NRC DISTRIBUTION FOR PART 50 DOCKET MATERIAL
(TEMPORARY FORM)

Mr. George Lear, Chief
Operating Reactors Branch #3
Division of Reactor Licensing
Office of Nuclear Reactor Regulations
U. S. Nuclear Regulatory Commission
Washington, D. C. 20555

H. B. ROBINSON UNIT NO. 2
LICENSE NO. DPR-23
ADDITIONAL INFORMATION FOR ECCS ANALYSIS

0.4 DOUBLE ENDED COLD LEG BREAK (GUILLotine)

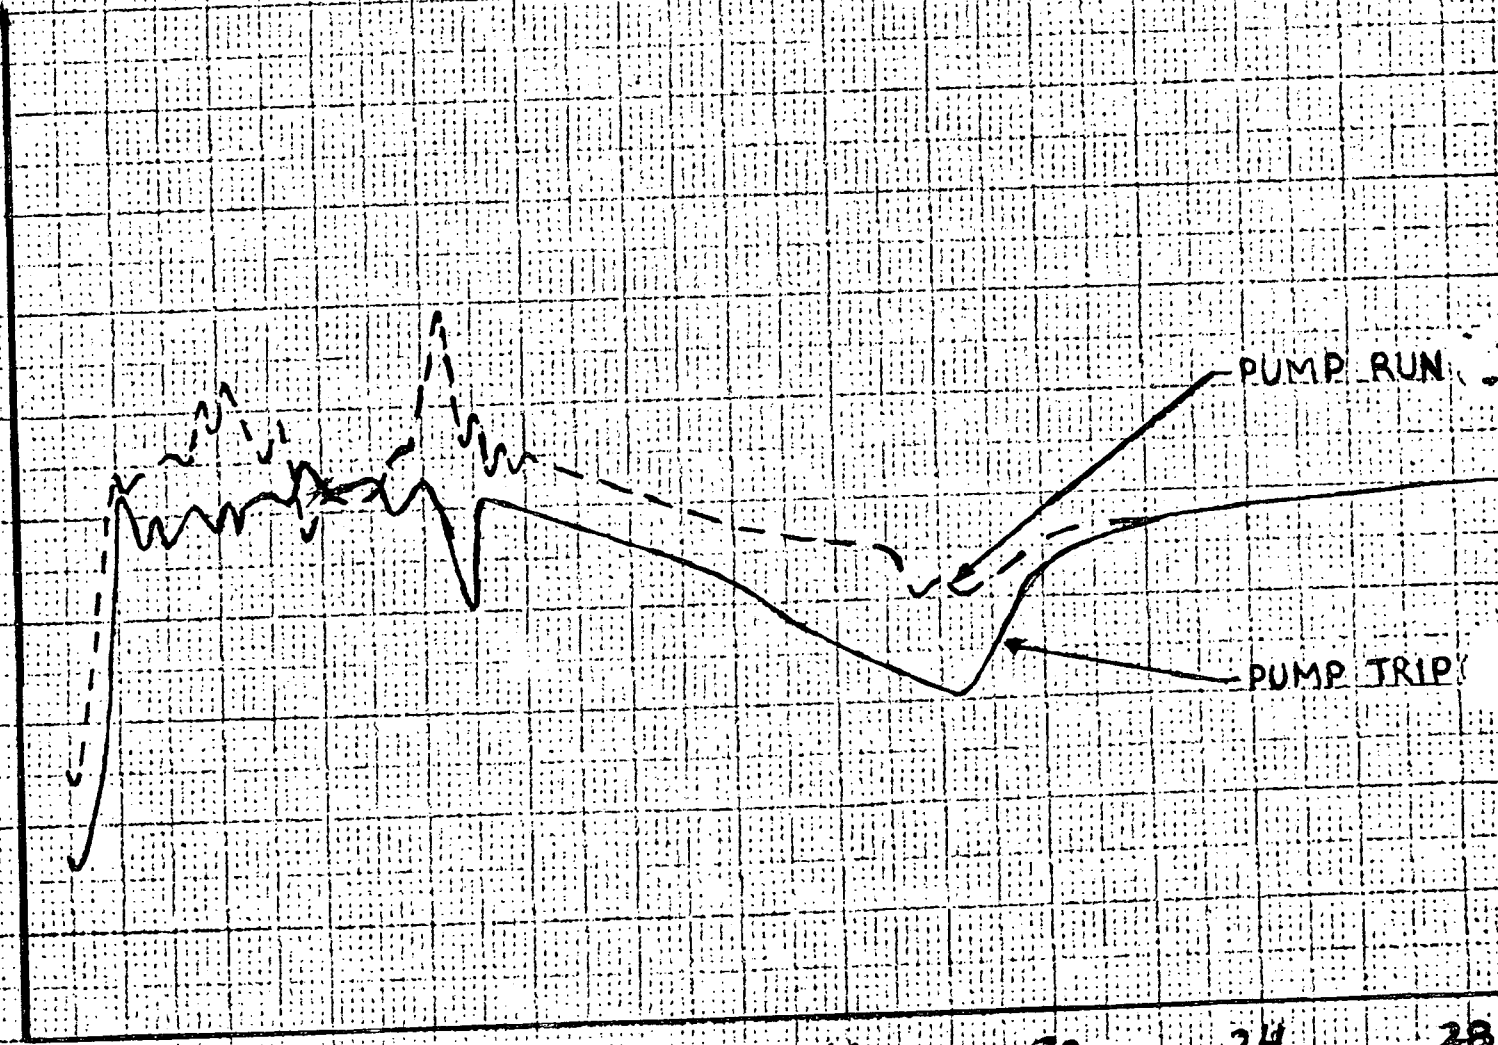
Q - For a C_D of 0.4, the generic 3-loop analysis showed a positive core flow between 10-13 seconds compared to Figure 2-9c which shows a negative core flow during this period. . .

Re-run this worst-case with reactor coolant pumps running to confirm that the expected decrease in core flow after 10 seconds (with pumps running) would not cause an increase in PCT.

A - Figure 1 shows plots of the core flow during blowdown for the Double Ended Cold Leg Break with $C_D = 0.4$ for two conditions:*

- 1) The "design" assumption that the RCS pumps trip at the time of the pipe break.
- 2) Assuming that the RCS pumps run at 100% speed during blowdown.

All other input assumptions were identical for these cases and the results are that the design case (pumps trip) had a peak clad temperature 26 F higher than the pumps run case.

This confirms the results and conclusions reached in the generic 3 loop sensitivity study presented in WCAP 8356.
